Re: Comments on "Feasibility Study" and "Proposed Plan for
Remediation", Tutu Well Site, St. Thomas,
Virgin Islands

COMMENTS ON FEASIBILITY STUDY AND PROPOSED PLAN FOR REMEDIATION
TUTU WELL SITE, ST. THOMAS, UNITED STATES VIRGIN ISLANDS
SUBMITTED ON BEHALF OF L'HENRI, INC.

Comments
Final Remedial Investigation (RI) Report
Tutu Wells Site, Tutu, St. Thomas
Report Prepared by Geraghty and Miller (April 1995)
Comments by IT Corporation for L'Henri Inc. (June 7 1995).

Figure S-25

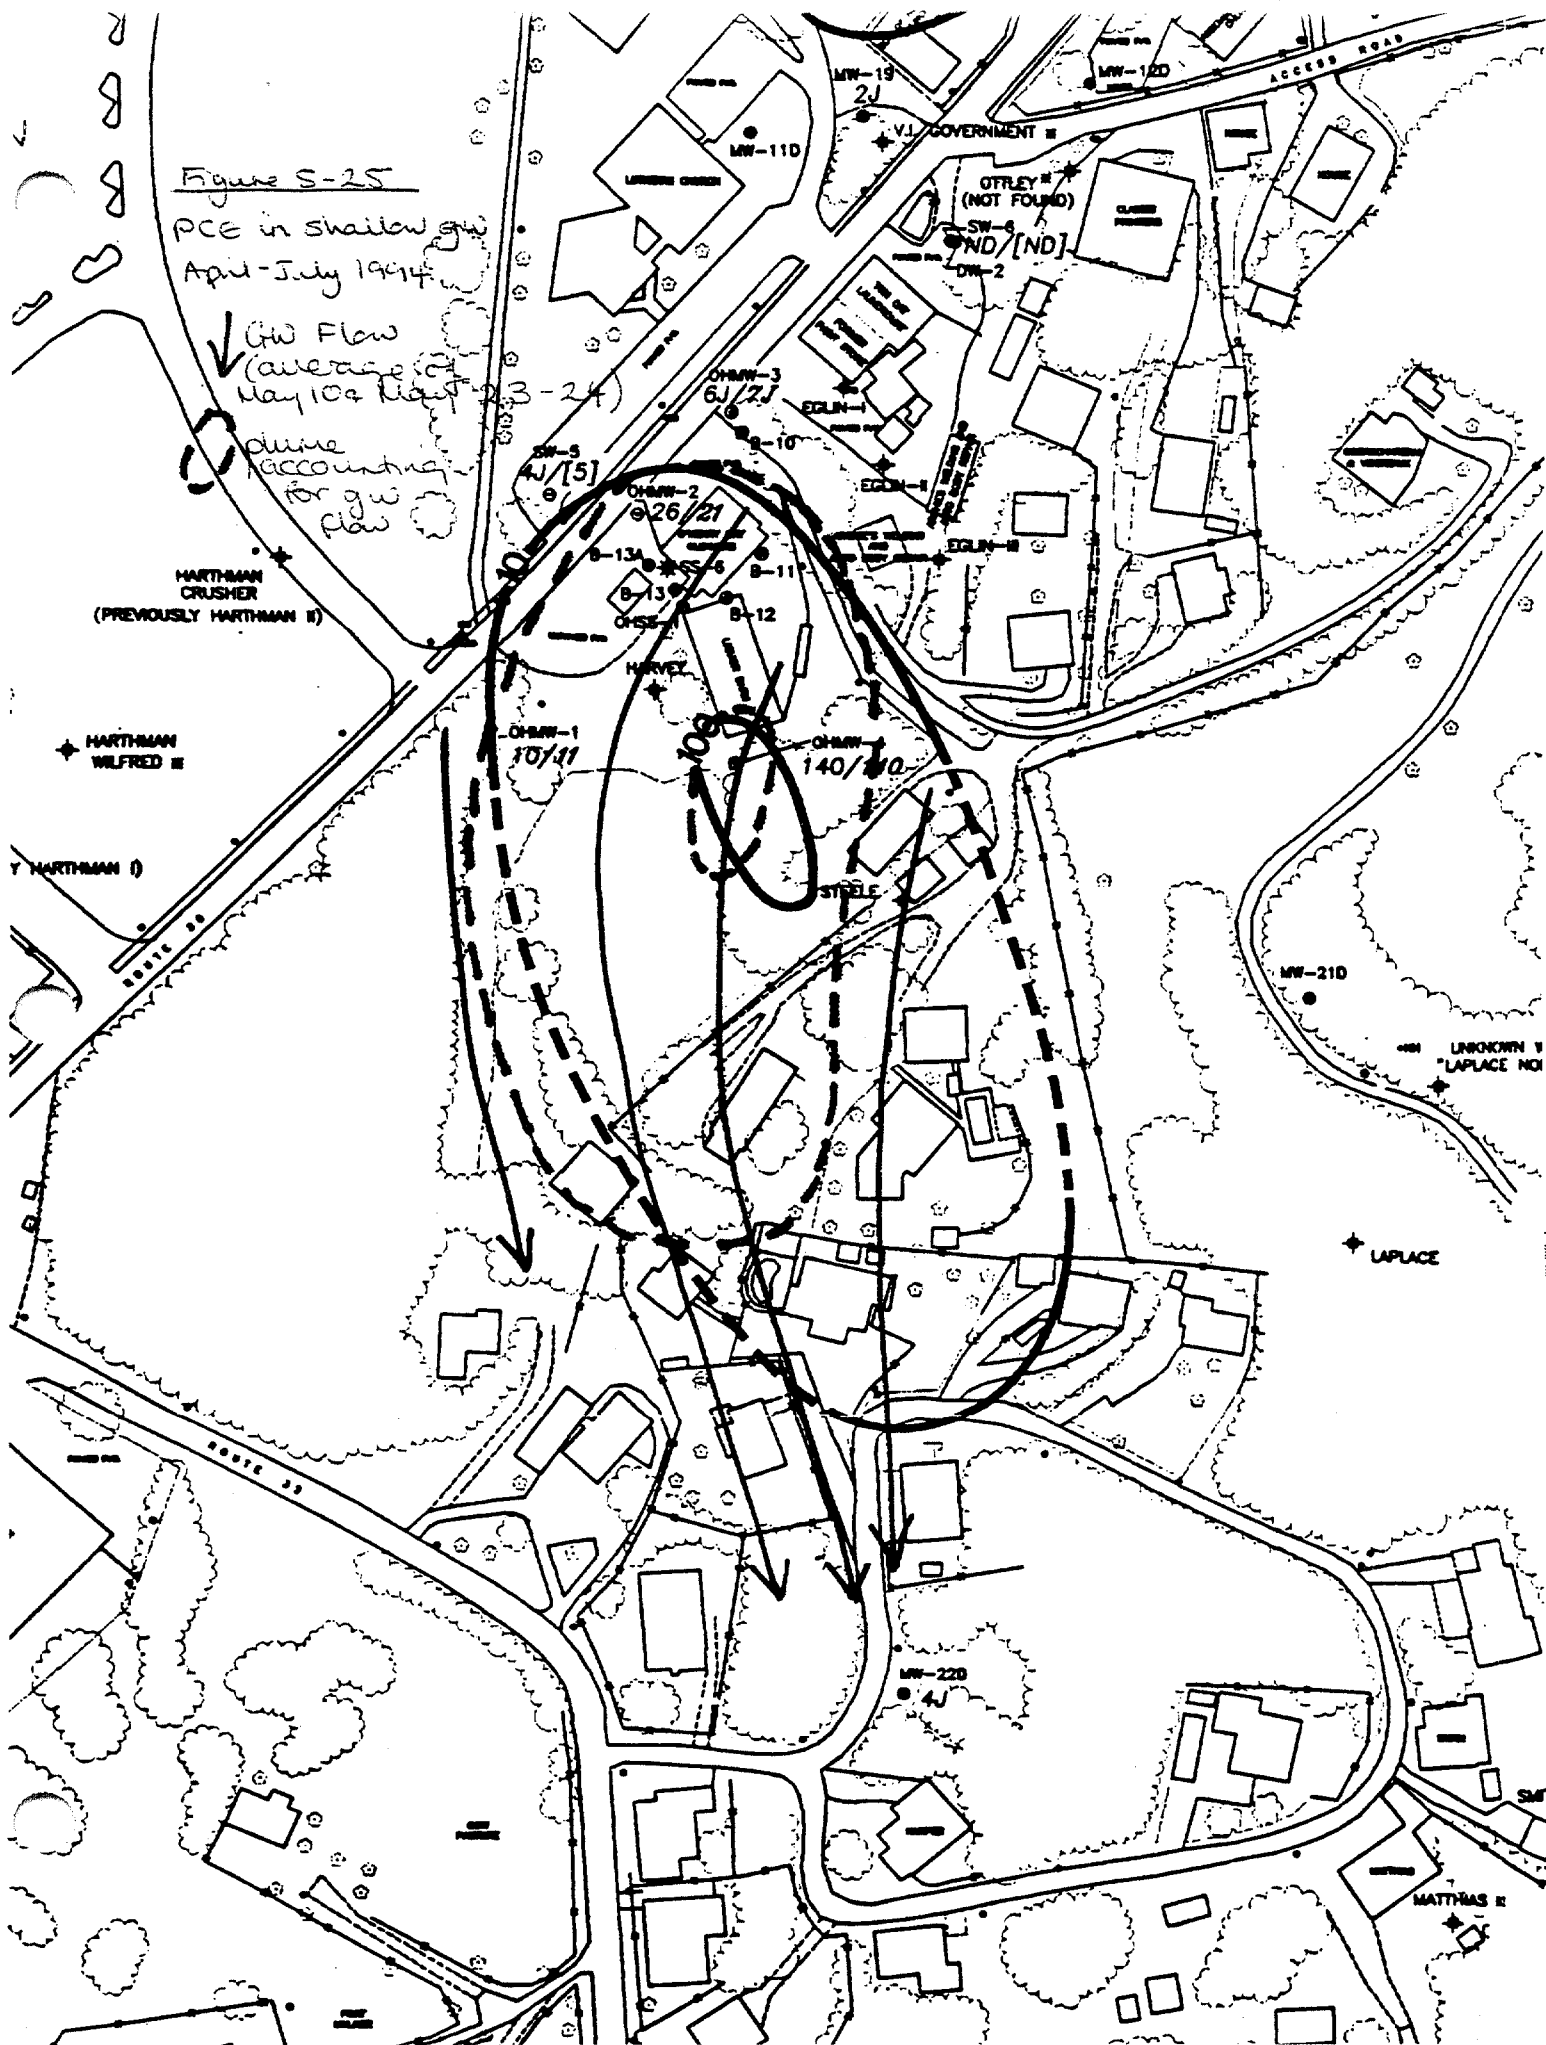
plume
accounting
for gw
flow

Figure S-27

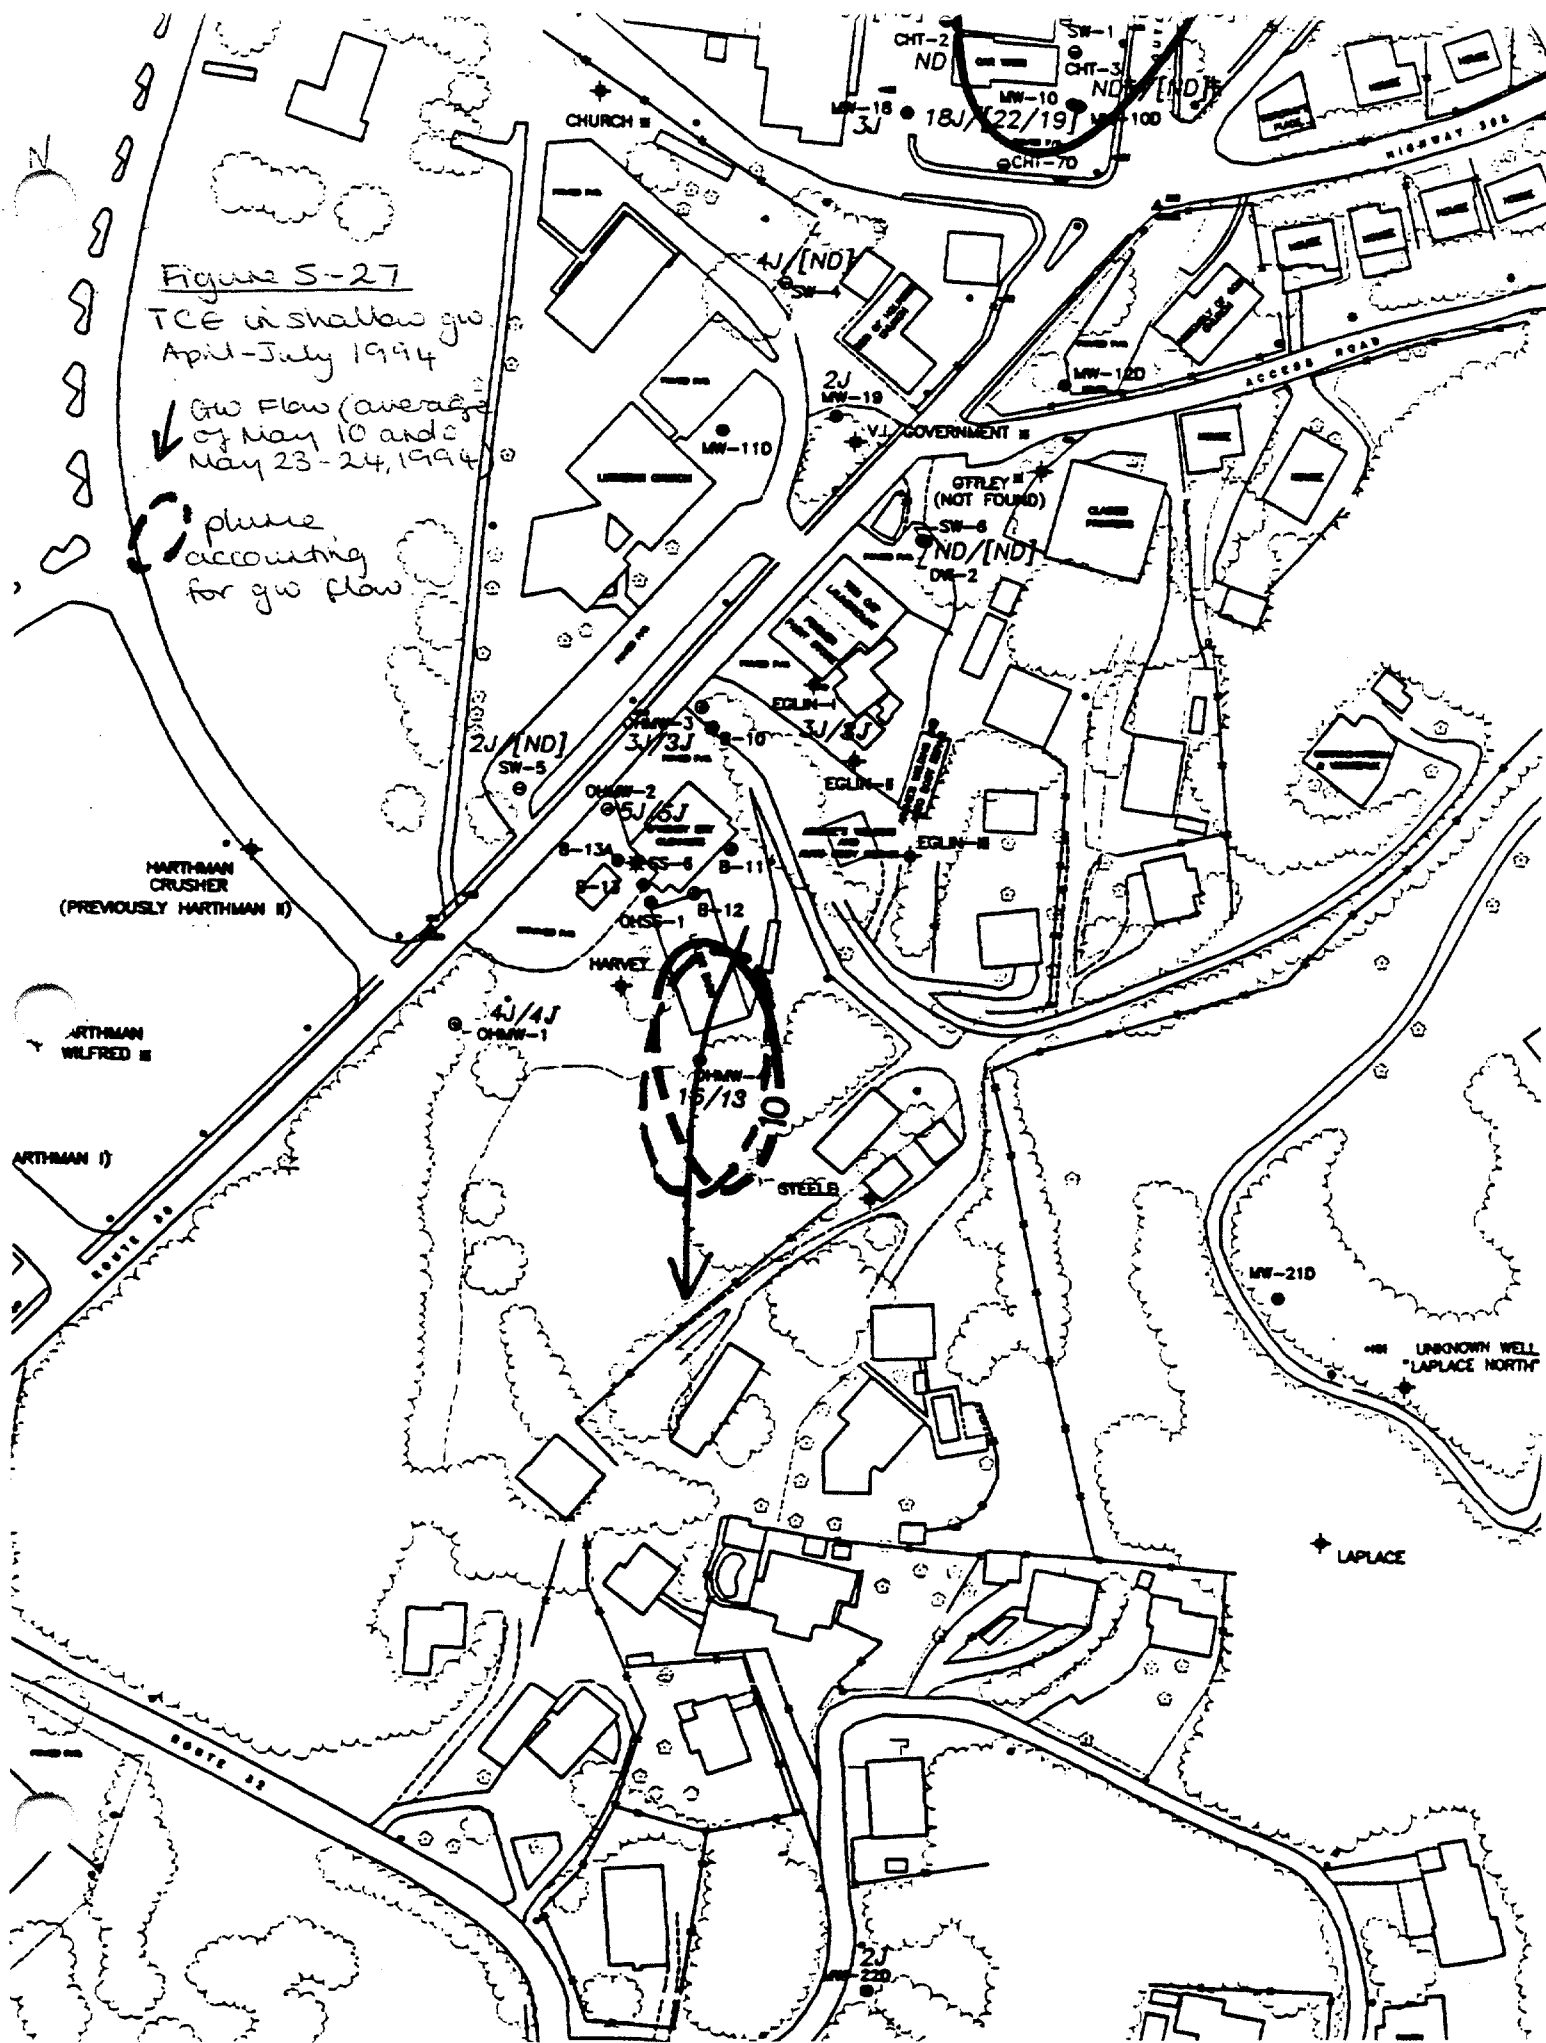
plume
accounting
for gw flow

Figure S-28

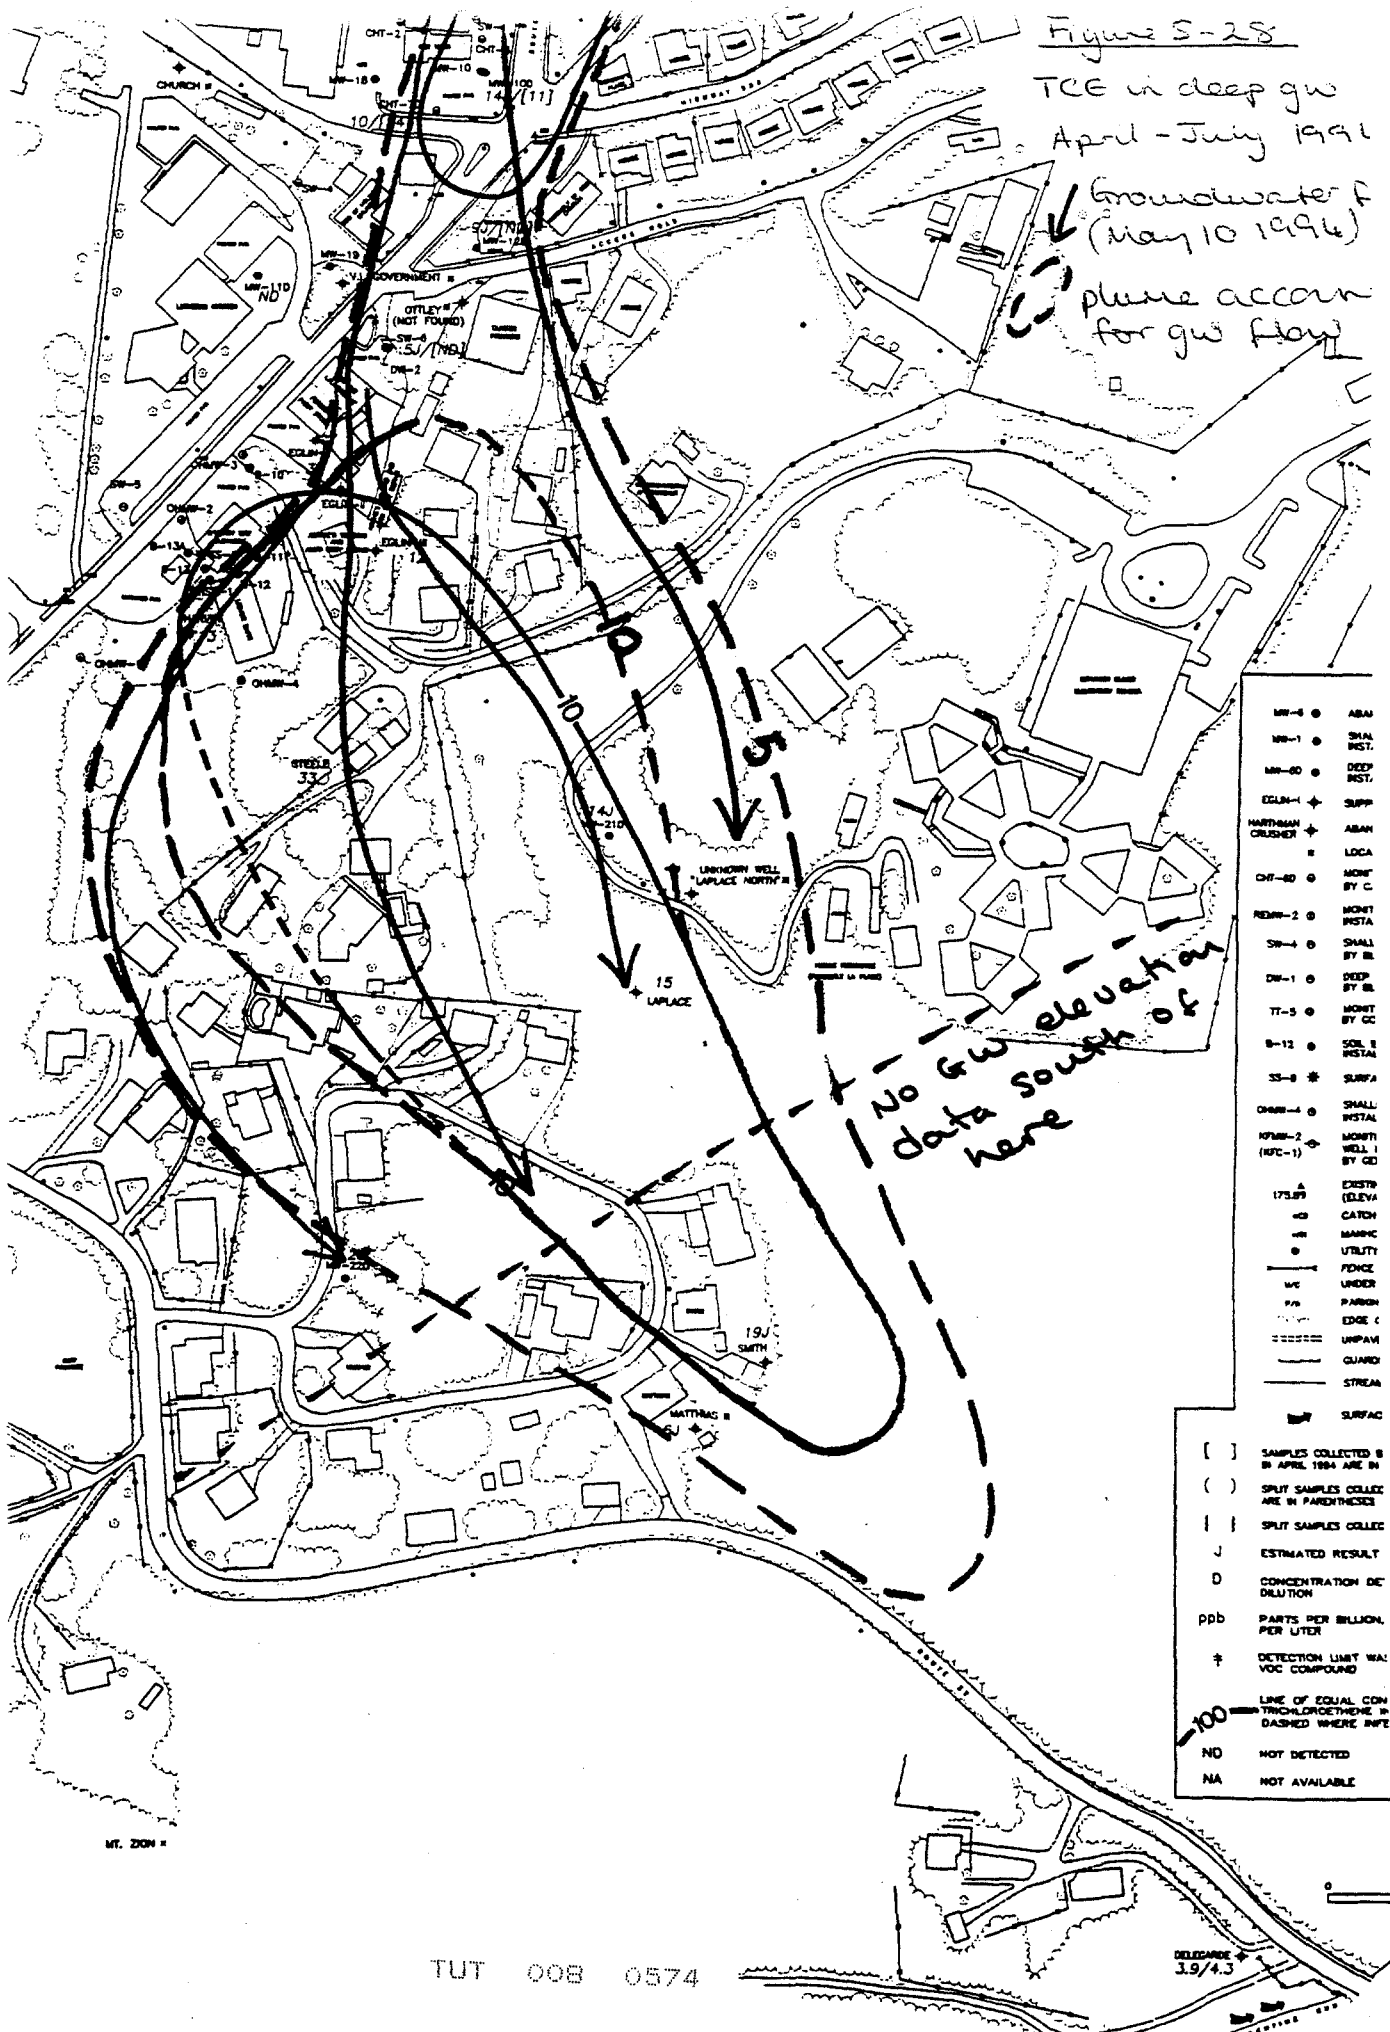
plume accorn
for gw flow
